SUBJECT: Notice of Deficiency (NOD): 300-Pound Open Burn Unit.  
(ref yr 20 Sep 96 ltr, same subj)

**HOLLOMAN AFB 300-POUND OPEN BURN AREA**

**RESPONSE TO**  
**CLOSURE PLAN NOTICE OF DEFICIENCY**

**Dated 20 SEPTEMBER 1996**

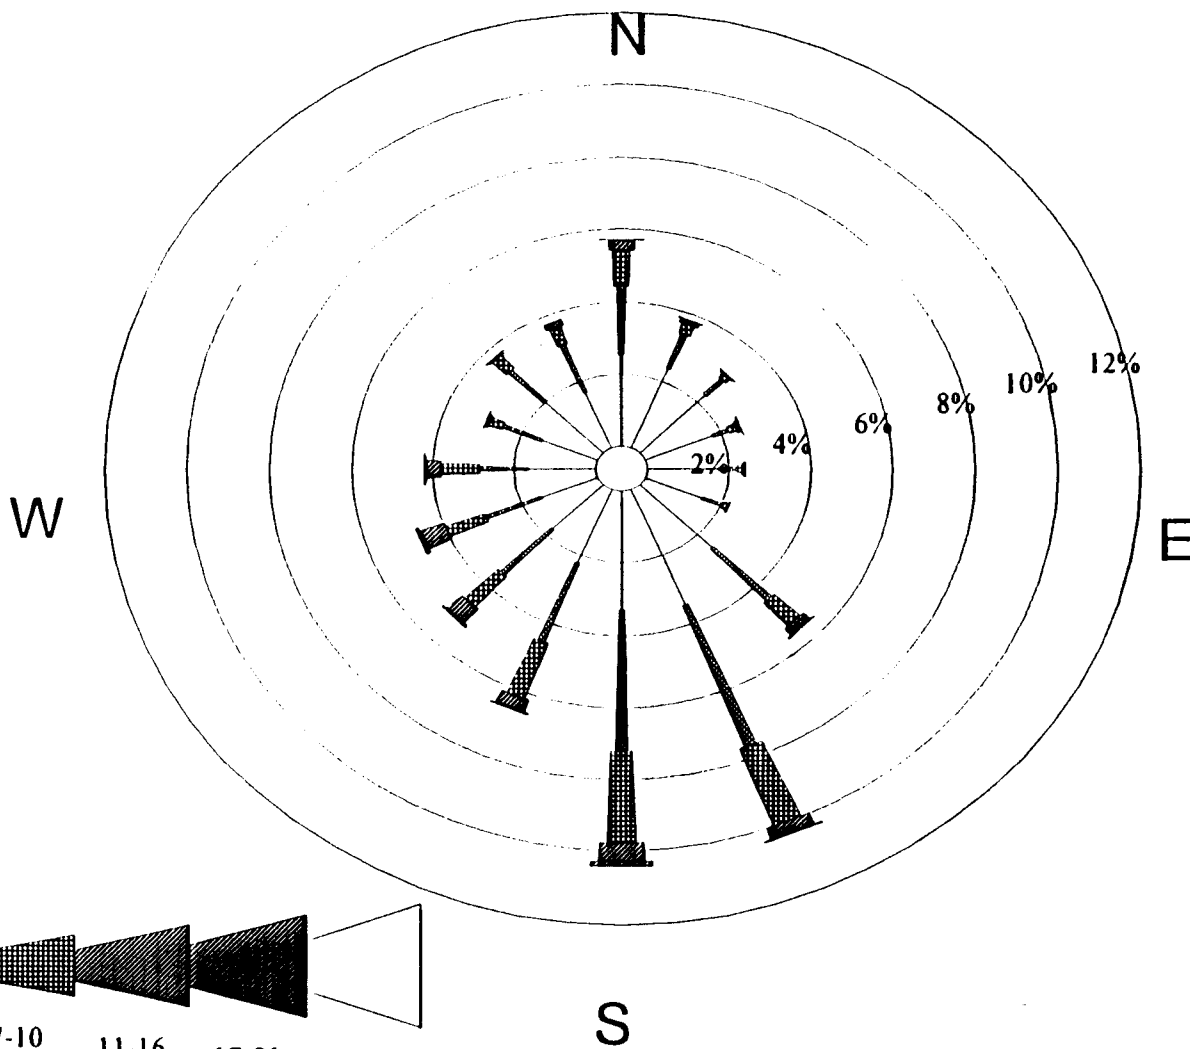
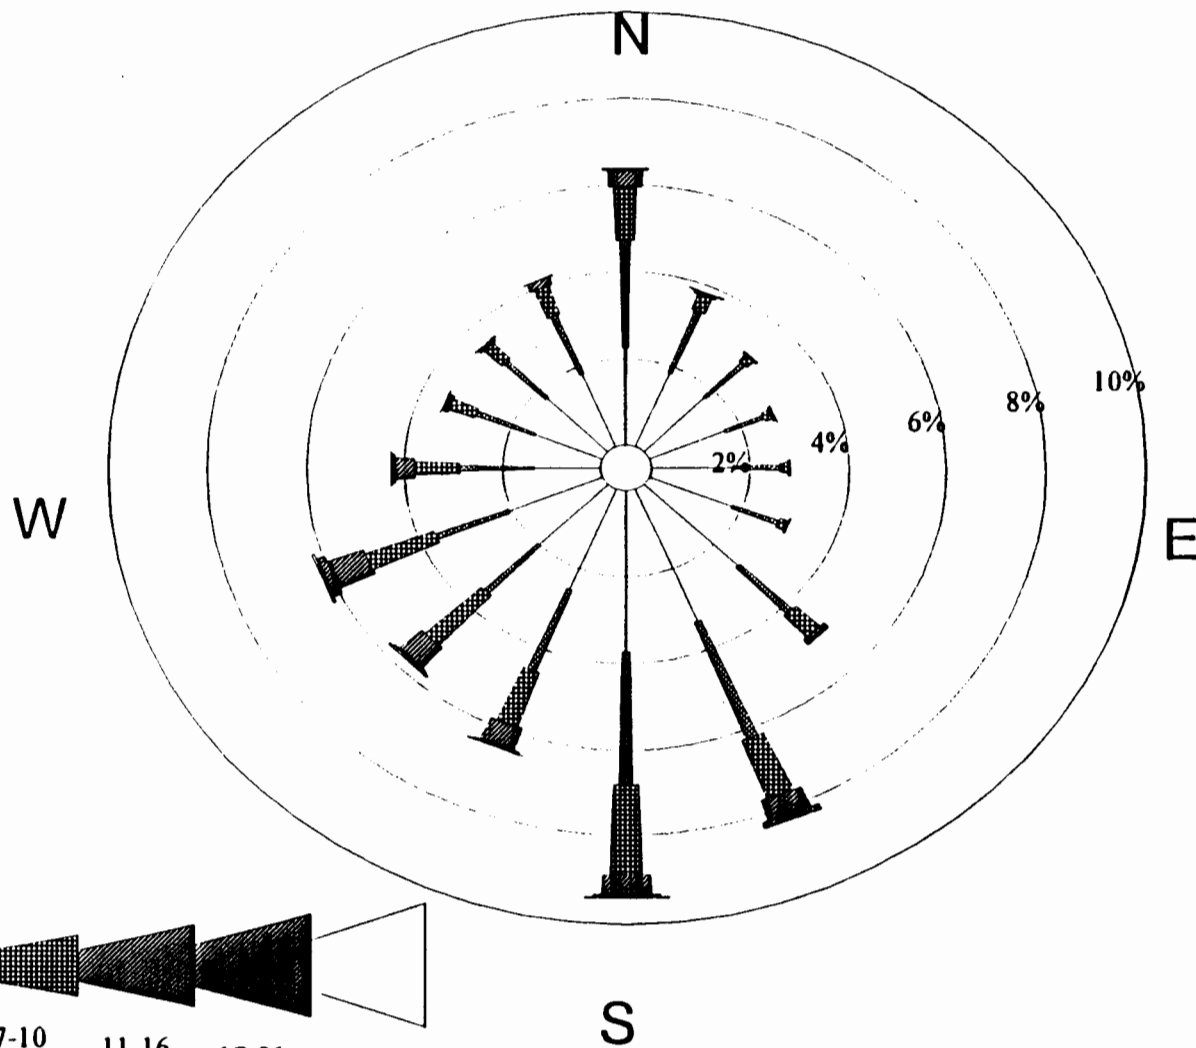
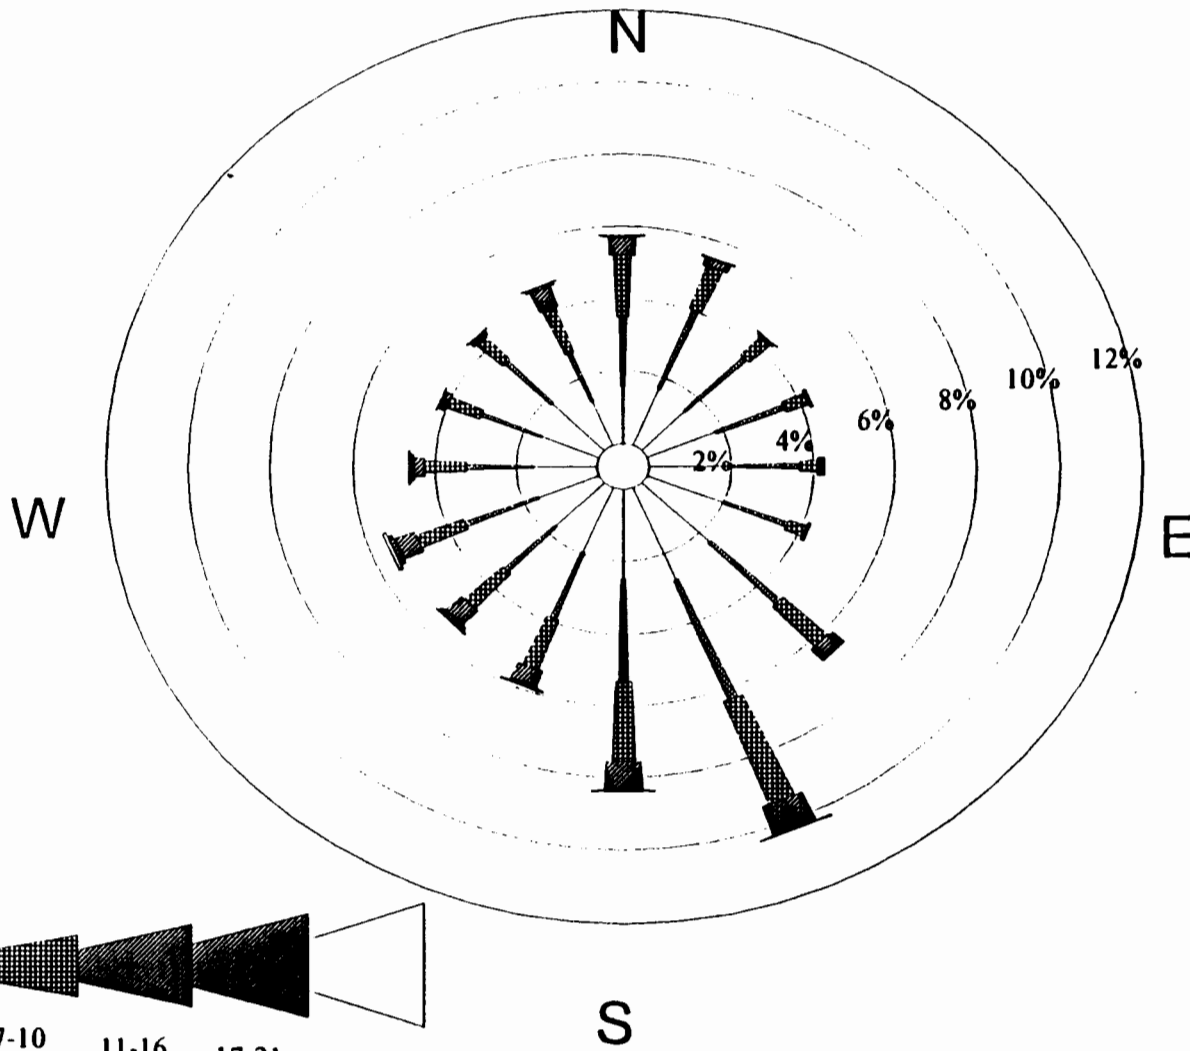
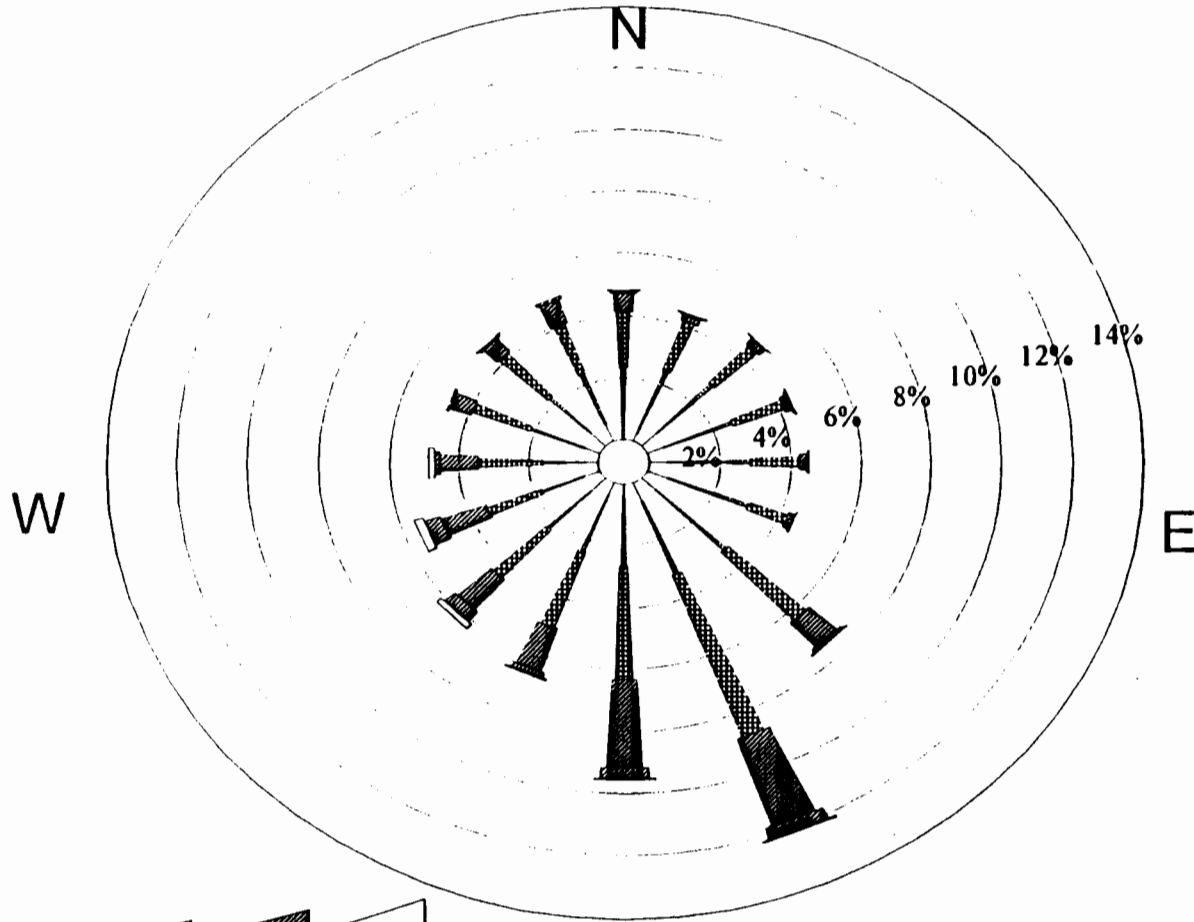
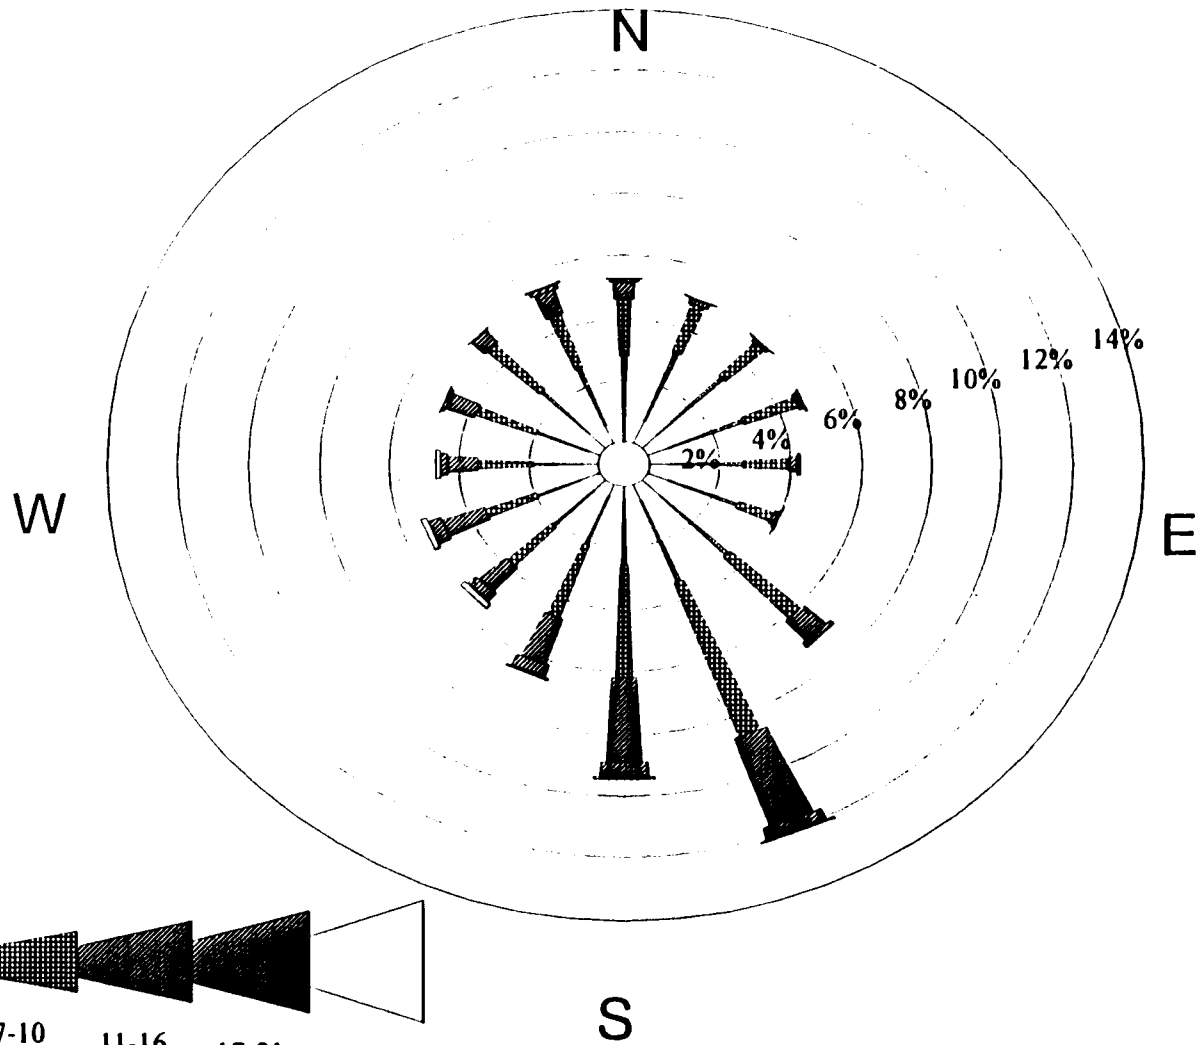
2. *Include a wind rose diagram showing prevailing wind directions and velocities;*

**Response:** The wind rose diagram is attached in Appendix B.
